CITY OF KIRKLAND
Planning and Community Development Department
123 Fifth Avenue, Kirkland, WA 98033 425.587.3225
www.ci.kirkland.wa.us

MEMORANDUM

To: File No. MIS09-00002, Sensitive Area Decision No. 1

Subject: CITY OF KIRKLAND PARKS AND COMMUNITY SERVICES
JUANITA BEACH PARK PHASE I IMPROVEMENTS -SENSITIVE
AREA DECISION LOCATED SOUTH OF JUANITA DRIVE AT 97th
AVENUE, PARCEL NO. 179150-0425

SHEET NO.
D-1
 X OF X SHEETS

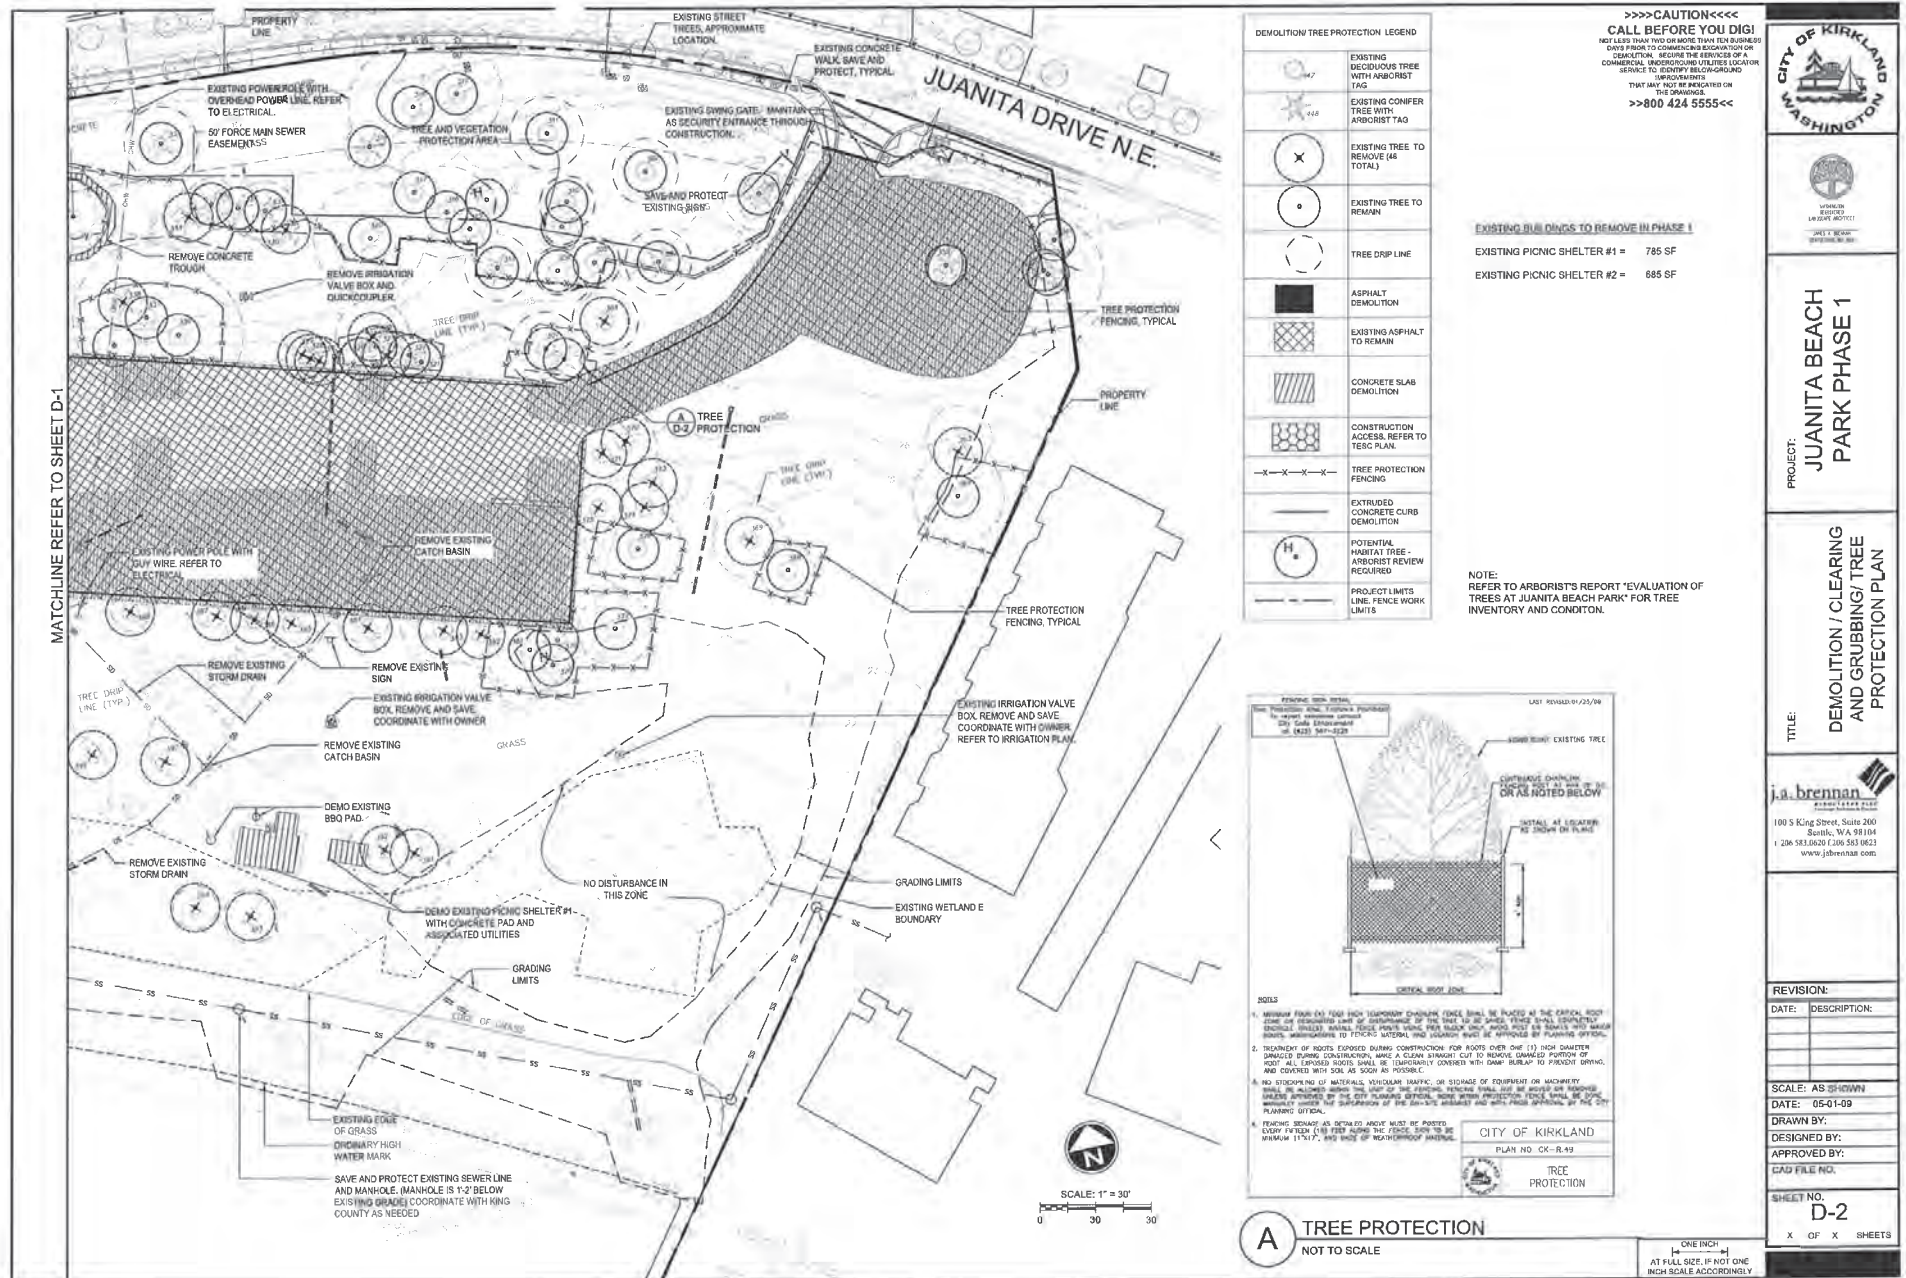
Under Phase I many trees will need to be removed or are recommended to be altered for habitat trees to accommodate the site grading, reconfiguration of the parking lot, and creation of the oxbow marsh. Attachment 1, Sheets D-1 and D-2 contain the proposed tree retention plan.

(Refer to plan sheet D1 and D2 Demolition/ Clearing and Grubbing/ Tree Protection Plan)

- c. Revise plans to indicate the existing trees to be retained removed and transformed into habitat trees. Preserve trees located within wetlands and stream buffers and incorporate the City's Urban Forester recommendations for additional tree retention and protection where feasible. Revise plans to show tree protective fencing consistent with the Urban Forester recommendations and Chapter 95 requirements (see Conclusion II.A.1.b.).
